Date	Group.	No.	Page
05.11	SC0351		1(3)

Fifth Wheel Mounting Bolts

SAFETY RECALL INFORMATION:

Repair

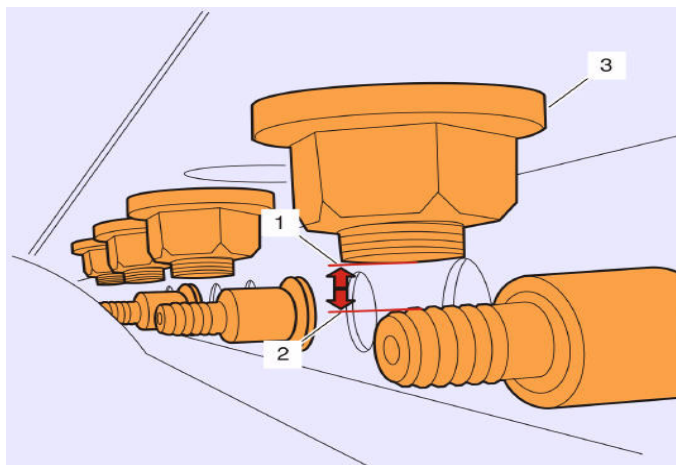
The concern is that there may be interference with the fifth wheel mounting bolts used to secure the fifth wheel to the frame. This interference can prevent the bolts from being torqued to specification. If this occurs, the bolt(s) may fail, which in extreme cases may result in the fifth wheel coming loose.

1. Inspect the fifth wheel mounting bolts. If the bolts are hitting or there is interference complete the following procedure. If the bolts are not hitting or no interference is occurring, no further action is required.
2. Park the vehicle on a level surface with the transmission in neutral and wheels chocked.
3. Remove all fasteners mounting the fifth wheel to the fifth wheel brackets.
4. Install the new fasteners mounting the fifth wheel to the fifth wheel angles and torque to 320 Nm ± 50 Nm (236 ft-lb ± 37 ft-lb).

NOTE: Ensure the fifth wheel is aligned properly and has not moved from its original mounting location.
